INDESIT company

Model type:
WA6IT

Commercial code:
F026878

Notices

FIG. 1

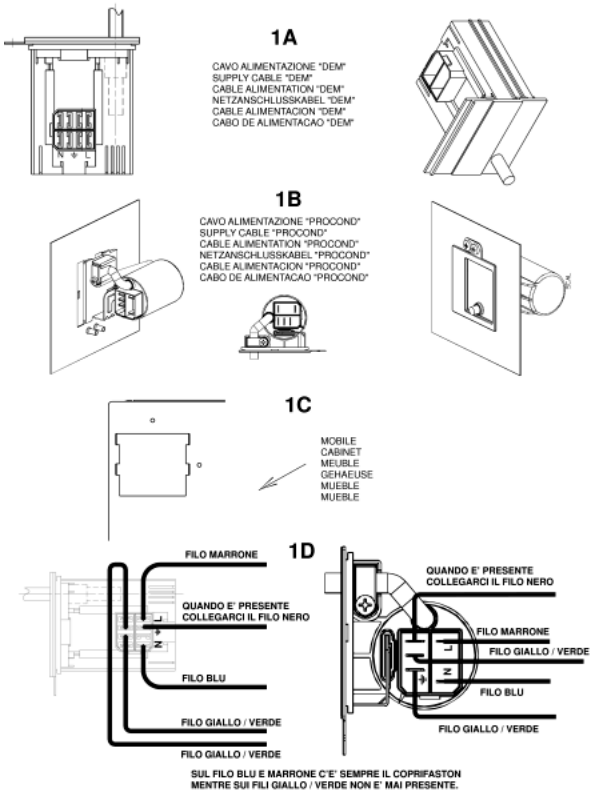
n1040279: Heater retaining element bracket and counterweight fixing

From serial no. 21015.001, a heater retaining element bracket (see fig.3) has replaced the heater retaining element protection Sat code 055036 (see fig.4) on all plastic tanks installed in washing machines produced in the Teverola factory.
The new part (fig. 1A) is fixed to the bowl with a self-tapping screw from the inside outwards and differs from the one used in the Comunanza factory (fig. 1B) in the fixing hole which is not threaded.
In order to reduce the number of parts used, only kit 058523 is managed and which, if used on the Teverola washing machines,

must be fixed with a self-tapping screw, instead of metric, after widening the tapped hole with a suitable drill bit.
When inserting the heater retaining element, particular care must be taken so that it is fitted correctly (Fig. 3).
The plastic tanks to be arranged for the guide have the same Sat code as those with the protection.

FIG. 1

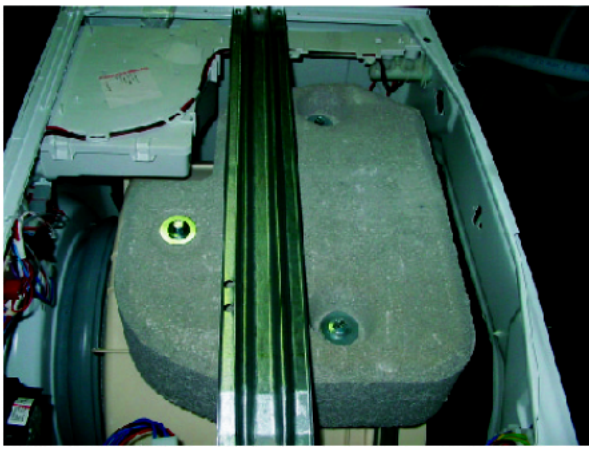
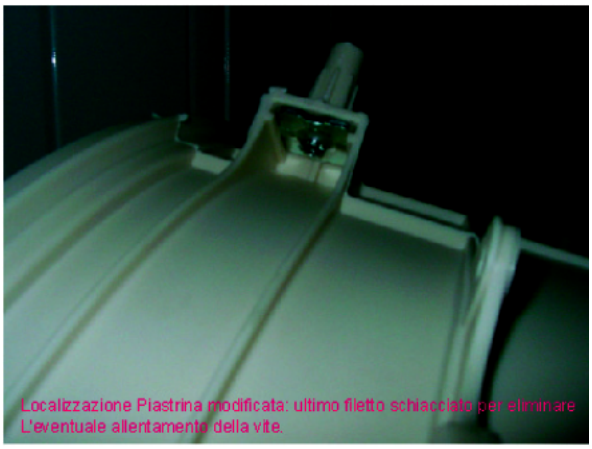
>From serial no. 21121.0001, the counterweight Fig. 2B with outlet increased by 5 mm in the centre has replaced the previous counterweight Fig. 2A.
The new counterweight (fig. 5) is fixed using three M8 X 63 mm screws with washer code 092016 (see fig. 8) and three plates with the last thread flattened (fig. 6) to prevent accidental loosening of the screw.
All the plates code 055038 in stock in the Centralised Warehouse have been replaced and can also be used on premodification appliances.
The modified counterweight has the same Sat code as the premodification item (066615) that will be managed until stocks run out.
The new counterweight must be assembled using the new screws and plates (see fig. 7).
Both counterweights can be employed necessarily using the following fixing parts which are specific for each type of counterweight:

Insieme nuovo fissaggio del contrappeso.

Localizzazione Piastrina modificata: ultimo filetto schiacciato per eliminare
L'eventuale allentamento della vite.

Fixing parts for premodification counterweight (see fig. 9):
3 pieces code 055019 - Screw M8 X60 mm;
3 pieces code 055018 - Conical washer;
3 pieces code 034336 - Flat washer;

Fixing items for modified counterweight:
3 pieces code 092016 - Screw M8 X 63 mm with washer;
3 pieces code 055038 - Plate with last thread flattened;

Particolari per il fissaggio del contrappeso modificato:
N° 3 pezzi del cod. 092016 – Vite M8X63 mm con rondella incorporata.

Particolari per il fissaggio del contrappeso premodificato:
N° 3 pezzi del cod. 055019 – Vite M8X60 mm,
N° 3 pezzi del cod. 055018 – Rosetta conica,
N° 3 pezzi del cod. 034336 – Rondella piana.

FIG. n1040305fig01

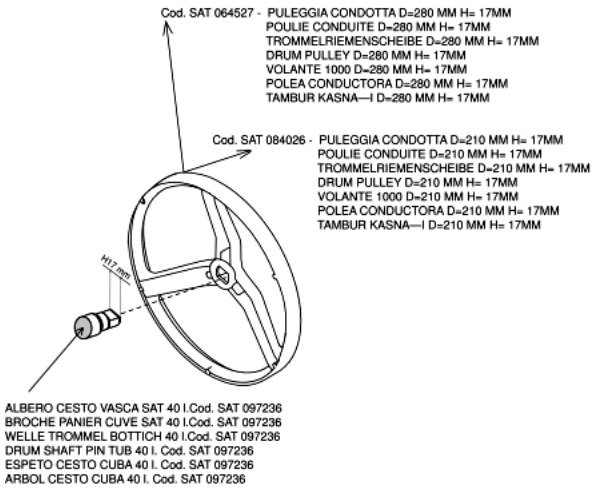
·Eeproms - The new software for the 40 litre EVO washing machines can also be used on premodification appliances; it is managed with the same Sat codes as the previous software, which is being immediately replaced as the new models enter into production.
·Pulleys - The use of a single 40 litre bowl assembly in Assistance involves management of the pulleys used in production (097268 and 097267) and also those required for creating the various combinations (see fig. n1040305fig.01):

Code 064527 - Pulley D=280mm H=17 mm;
Code 084026 - Pulley D=210mm H=17mm.

NB: From serial no. 31103.0001, all EVO appliances are equipped with a 40 litre bowl with H=15 mm drum cross shaft which will be managed with the same SAT code (097236) as the 40 litre bowl with H=17 mm shaft until stocks last.
To create the various combinations, the following pulleys are required:

Code 097268 - Pulley D=280mm H=15 mm;
Code 097267 - Pulley D=210mm H=15mm.
Exceptions to this are models W93UK (23330) and W103UK (23334) which are equipped with a 46 litre bowl; therefore if the bowl needs replacing code 096198 with 20 mm pulley cross shaft must be used.
In production, pulley code 064527 (diameter D= 280 mm and central hole H= 17mm) is used; therefore, when replacing the bowl, code 097269 (diameter D= 280 mm and central hole H= 20mm) must be used.
